Date: December 20, 2019
To: Plan Holders
Subject: Addendum No. 1 to the Bidding Documents for: ITB No. 2020-001

METCAD Mechanical System Replacement Project
1905 East Main Street
Urbana, Illinois 61802

Addendum No. 1 becomes a part of the bidding and contract documents and modifies the original bidding documents, dated December 4, 2019. Acknowledge receipt of Addendum No. 1 in the space provided on Bid Form. **FAILURE TO DO SO MAY SUBJECT BIDDER TO DISQUALIFICATION.**

LOWER LEVEL FLOOR PLAN - VENTILATION
SCALE: 1/4" = 1'-0"

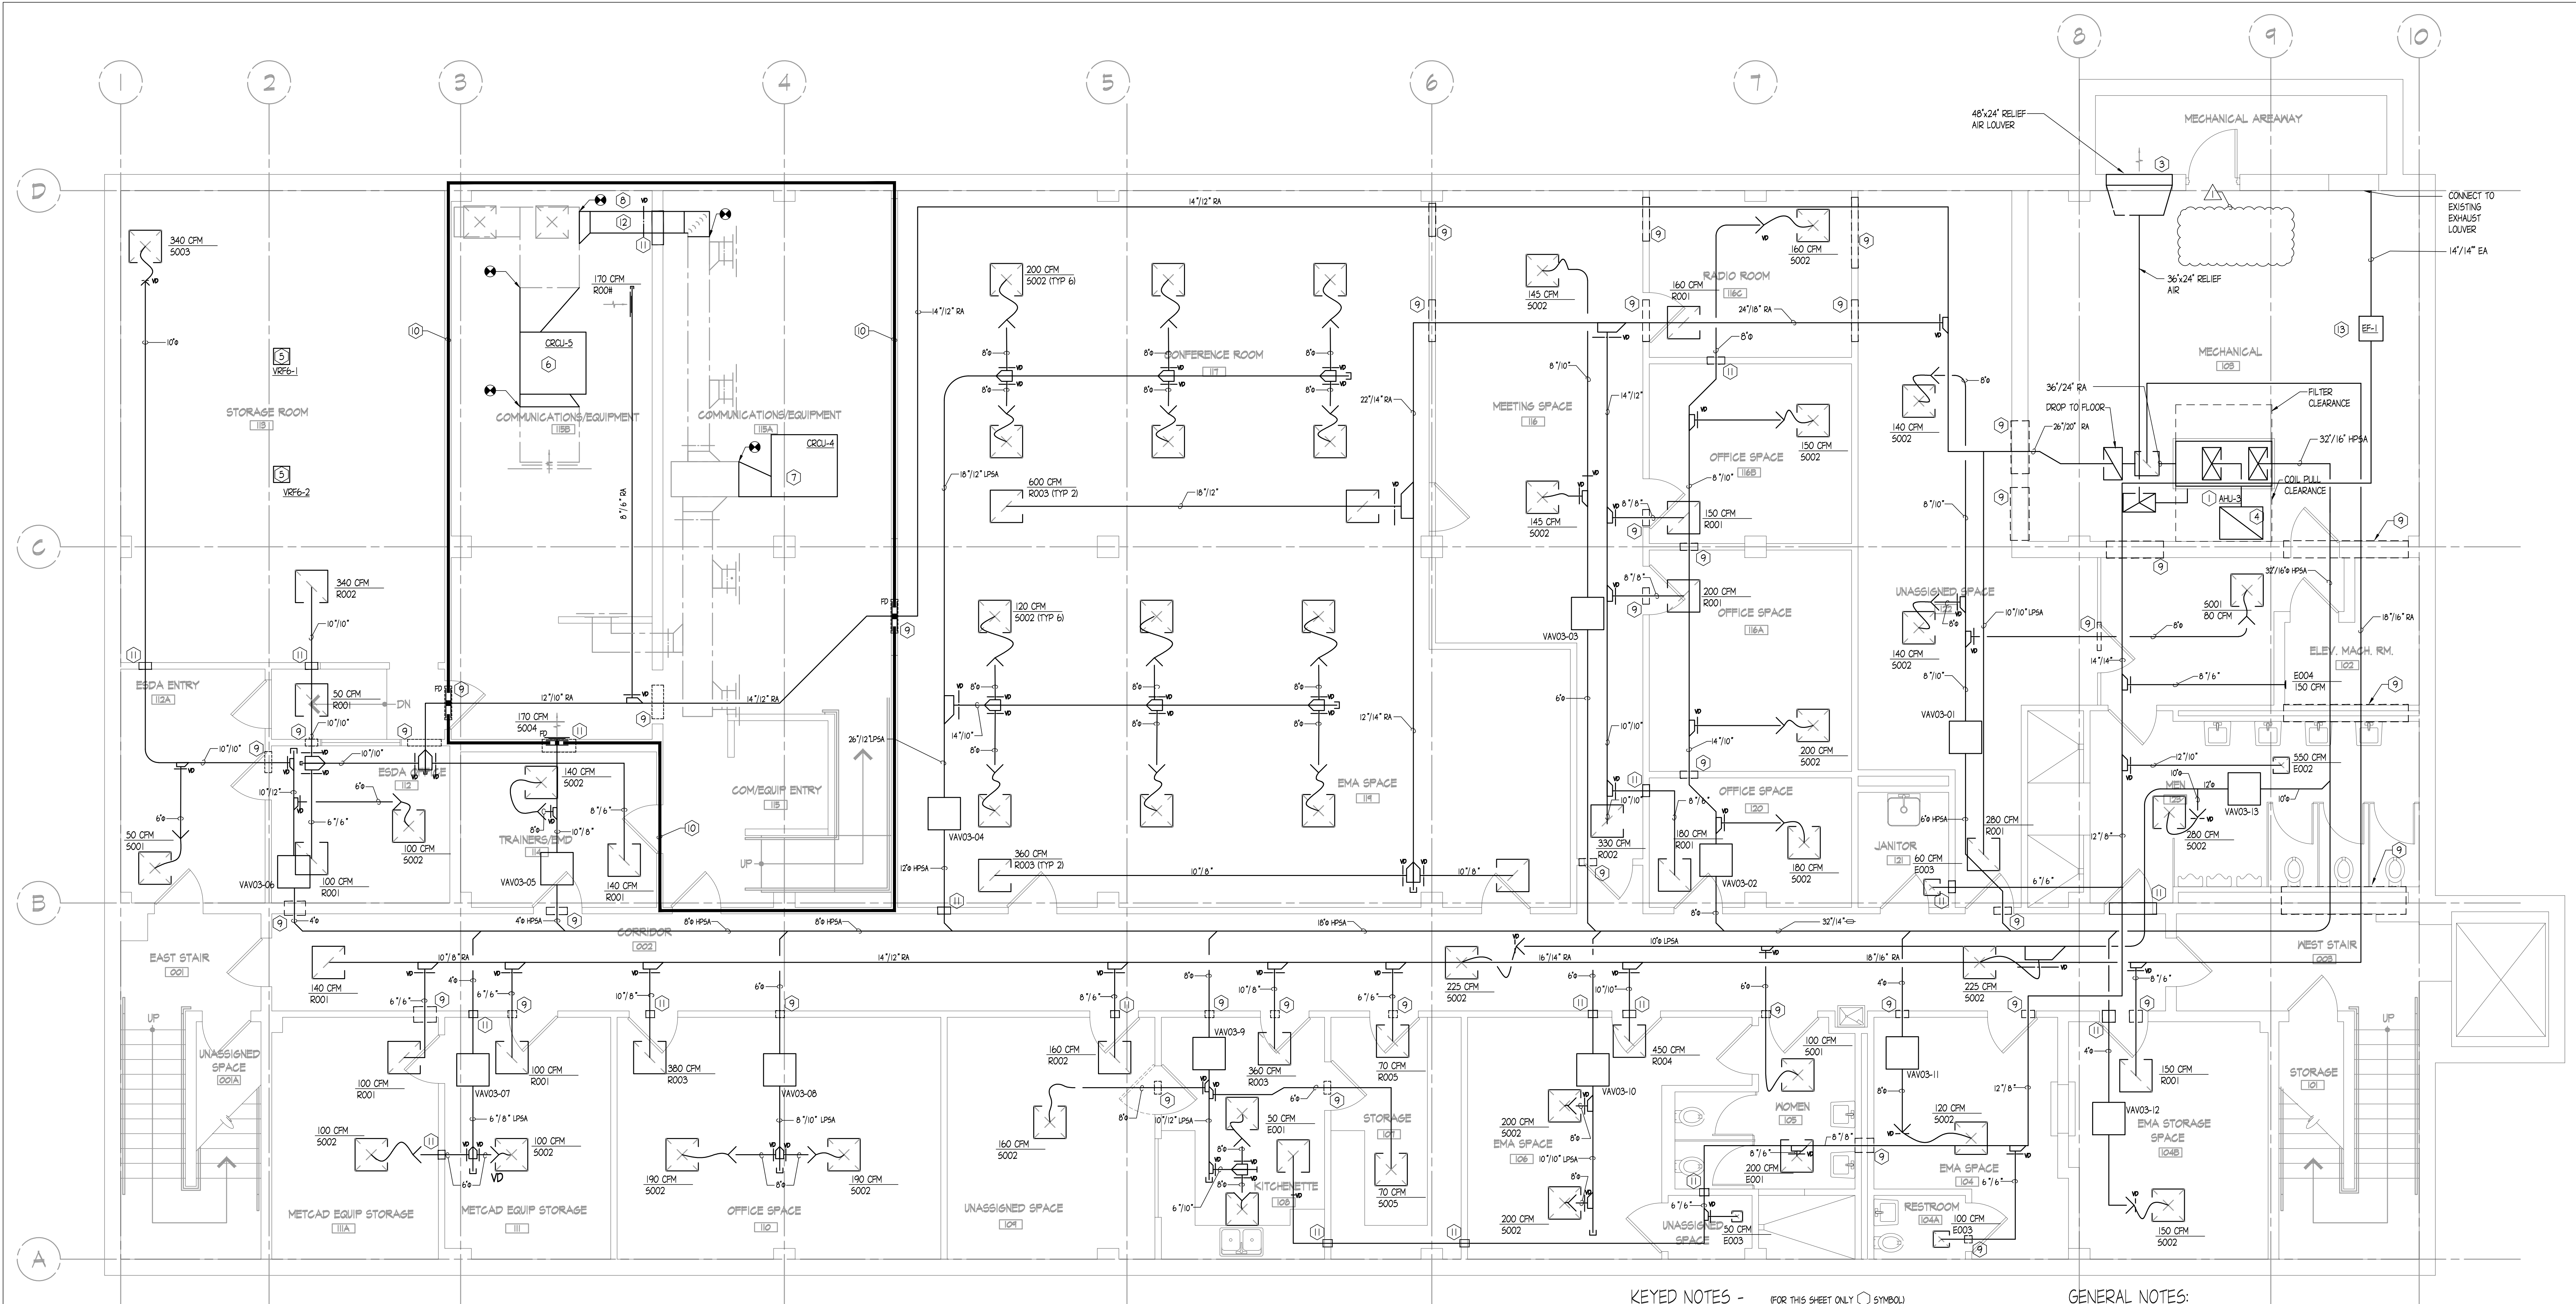
- a. General Notes - Add Note 9 and the following: "Protect sprinkler heads during ceiling removal and ceiling reinstallation. Provide new escutcheon plate as required for sprinkler head for ceiling re-installation. Approximately 150 sprinklers. Field verify exact amount of sprinkler heads."

- b. Corrected sheet title to "LOWER LEVEL FLOOR PLAN - VENTILATION".
 - c. Clarified double wall vs. single ductwork.
 - d. Clarified rectangular vs. oval ductwork.

- e. Added notes calling out available space above ceilings.
 - f. Revised OA intake ductwork for AHU-3.
- 11. Sheet V-2 - First Level Floor Plan - Ventilation - See Attached Revised Sheet V-2

SEAL	DRAWN: MSH DATE: DEC 4, 2019 PROJECT: 7205	APPROVED: JNG BID DOCUMENTS	SHEET: V-2
------	--	--------------------------------	------------

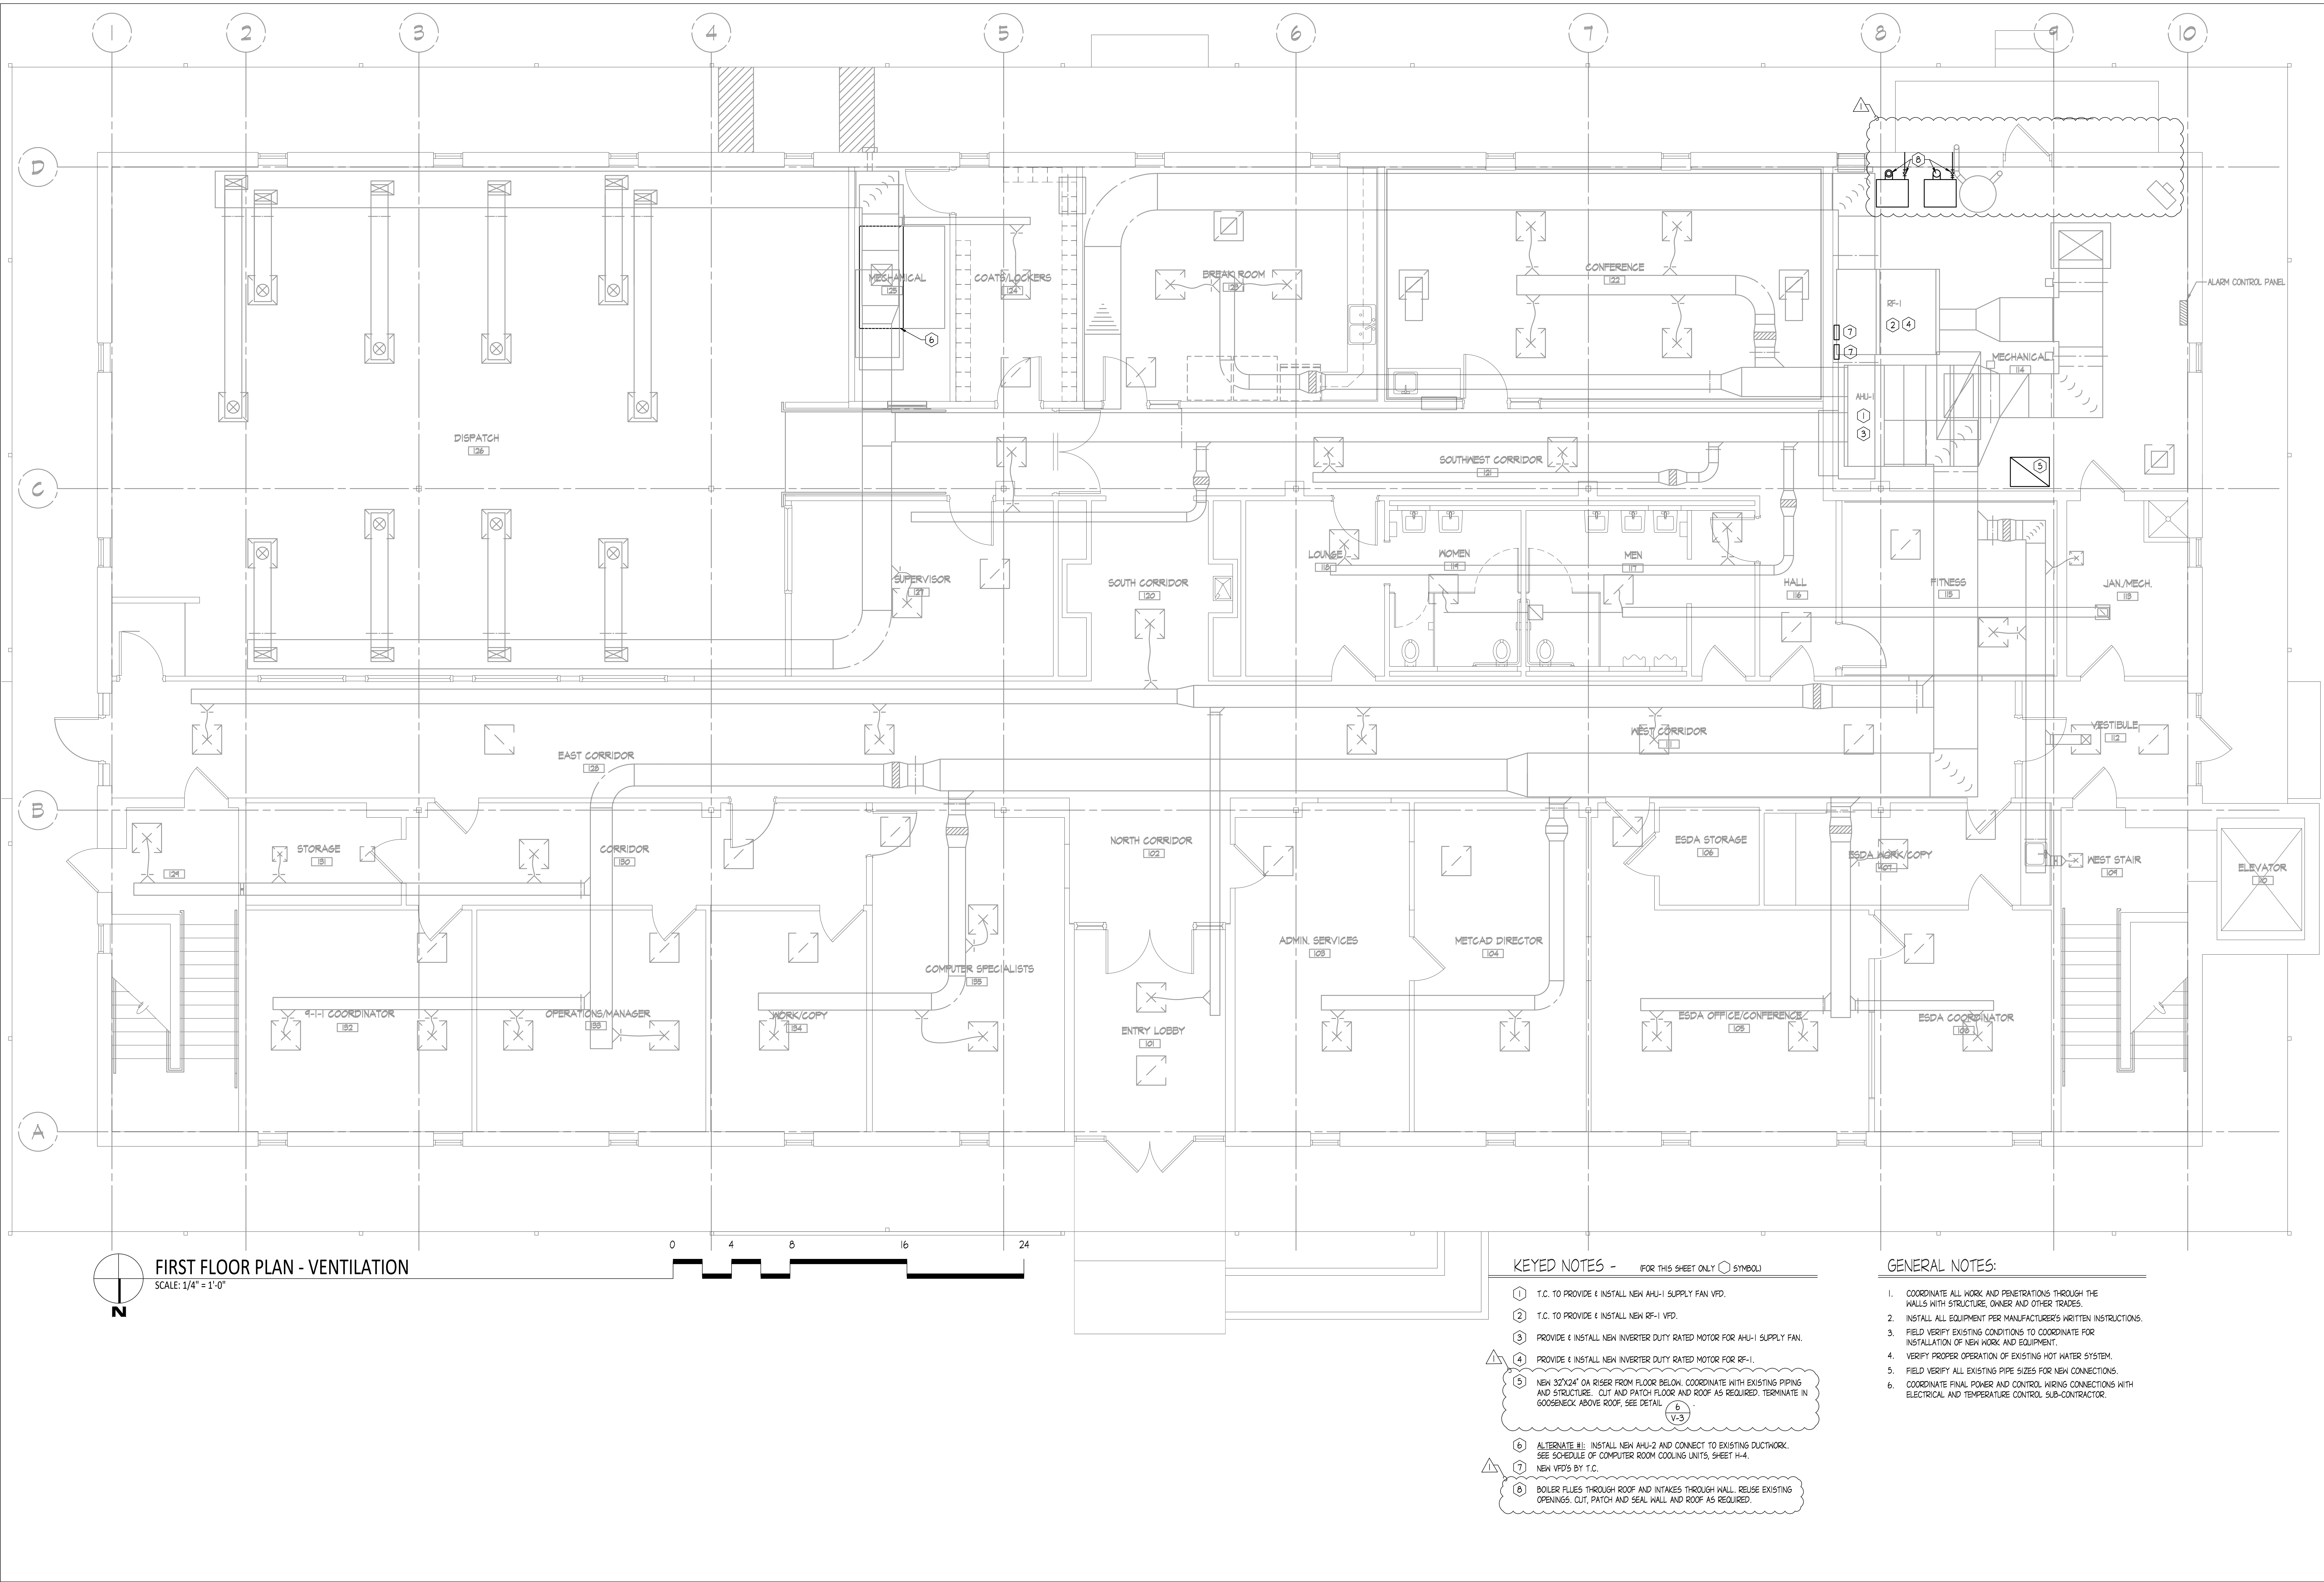
- a. Corrected sheet title to "FIRST FLOOR PLAN - VENTILATION".
 - b. Revised OA intake ductwork for AHU-3.
 - c. Revised closed combustion ductwork for new boilers B-1 and B-2.
